Apparels Village Ltd. (Shirts) - New Building 2

37, Khagan, Birulia-1340, Dhaka, Bangladesh

2 January 2024

2. Observations:

Column Layout plan and floor loading

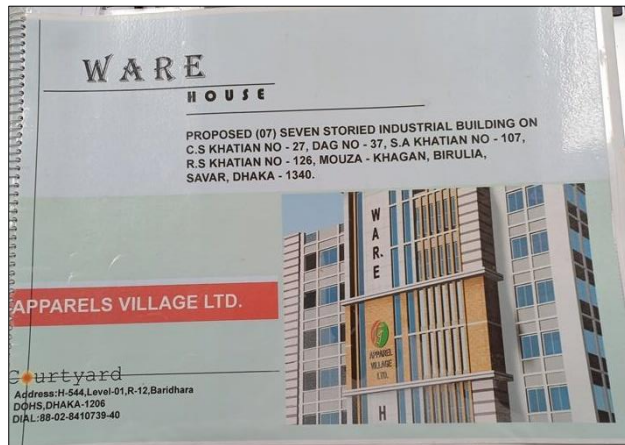
Observation-1: Stress in the column exceeds normal design limit. Building-8 (Warehouse-2)

Description: The cursory calculation indicates that column stress exceeds the normal design limit considering a typical floor live load of 6kPa, roof live load of 1.5 kPa, and concrete strength of 16.31 MPa and tensile re-bar strength 413MPa.

The building engineer is required to verify in-situ concrete stresses either by concrete cores (100mm dia. cores from column and floor based on material types) or existing cylinder strength data. Building Engineer is required to review design, loads and columns stresses based on in-situ concrete strength following recent building code.

During inspection, the load plan was not available. Building engineers is required to produce and actively manage a loading plan for all floor plates within the factory considering floor, column and foundation capacity.

SL. No.	Observation	Action Plan	Timeline
1.	Stress in the column exceeds normal design limit. Building-8 (Warehouse-2)	Building Engineer to review design, loads and column stresses.	within 6 weeks

2.	Stress in the column exceeds normal design limit. Building-8 (Warehouse-2)	Verify in-situ concrete strength by taking concrete core or adequate cylinder test report from all types of structural members.	within 6 weeks

3.	Stress in the column exceeds normal design limit. Building-8 (Warehouse-2)	Produce and actively manage a loading plan for all floor plates considering floor, column and foundation capacity.	within 6 months

4.	Stress in the column exceeds normal design limit. Building-8 (Warehouse-2)	Carry out remedial works where required.	within 6 weeks
5.	Stress in the column exceeds normal design limit. Building-8 (Warehouse-2)	Continue to implement floor loading plan	within 6 months

Proposed for the seven storied and constructed up to six storied.

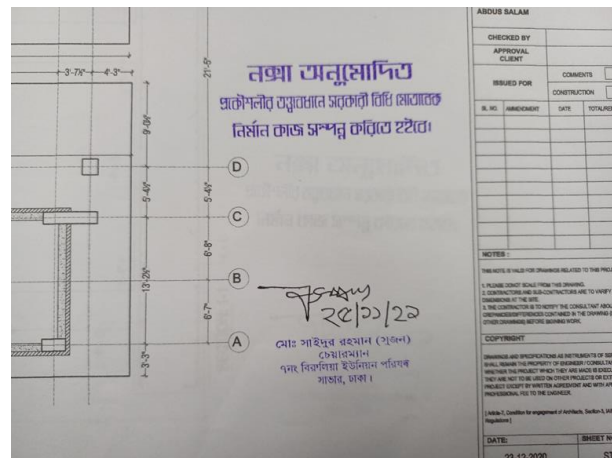
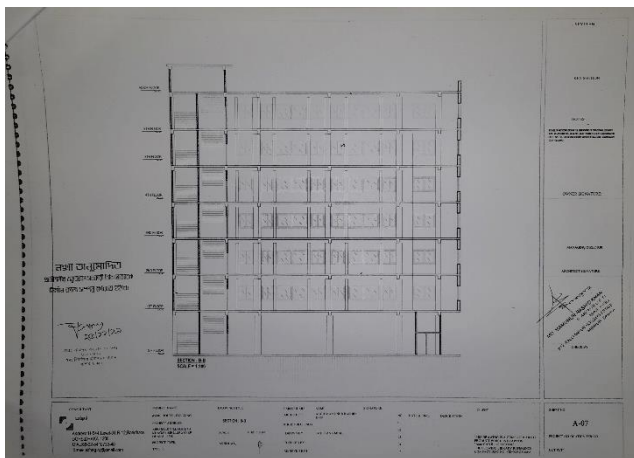
Observation-2: Detail Engineering Assessment (DEA) needs to be performed before Future Vertical Extension. Building-8 (Warehouse-2)

Description: The building permission layout is for seven storied structure from Birulia union parishad dated 25-Nov-2021. But the construction of the building was started in October 2020 and completed up to six stories in February 2023.

So, there is a possibility of future vertical extension. Building engineer is required to prepare full set of drawing & documents for the seven storied structure prior to commencement of further extension work.

6.	Detail Engineering Assessment (DEA) needs to be performed before Future Vertical Extension. Building-8 (Warehouse-2)	Prior to the vertical extension, building engineer is required to produce a Detailed Engineering Assessment (DEA) of the structure according to BNBC and submit it to RSC for review.	within 6 weeks

7.	Detail Engineering Assessment (DEA) needs to be performed before Future Vertical Extension. Building-8 (Warehouse-2)	Carry out recommendation as outcome of the DEA.	within 6 months
